TE Connectivity

Product Change Notification: PCN-26-271864

HD MATENet 1+2 Group C Header Interface Drawing Change

Pos 3 & 4 before change

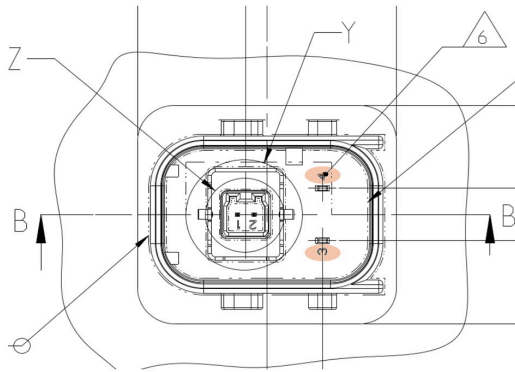
Please be aware the document 208-18143 has been updated to make a correction of the contact position 3 & 4 (not affecting below listed part numbers of mating connectors).
